P&Z #18-12000028 Responses to December 28, 2020 Email

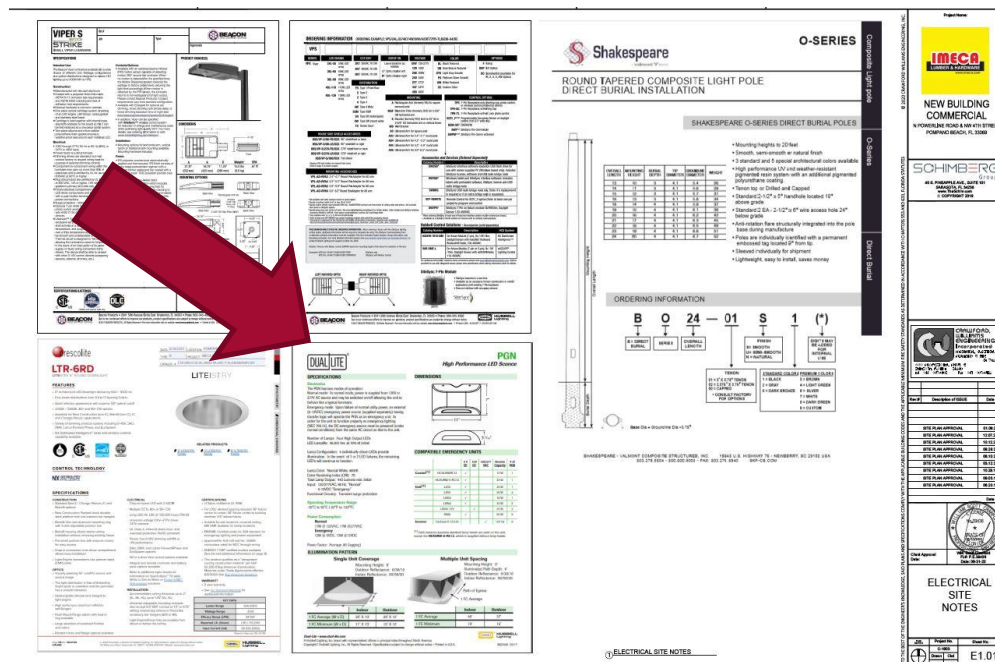
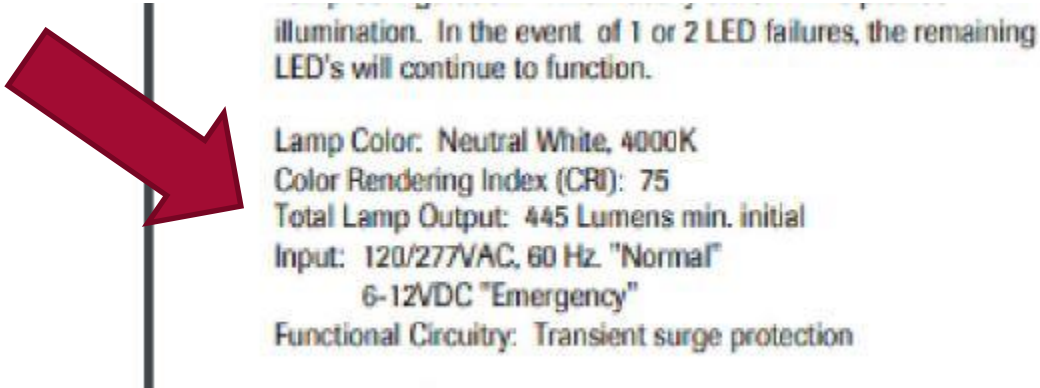
3. The cut sheet for the wall pack lighting fixture shows that it does not comply with 155.5401. The lumens range is 3,200-11,000. A maximum of 900 lumens is permitted. Revise the fixture type and update the drawings as well. **The wall pack clearly reflects a maximum lumen output of 445. See clip below in terms of where to find that information.**

Within that detail please refer to the following section indicating 445 lumens.
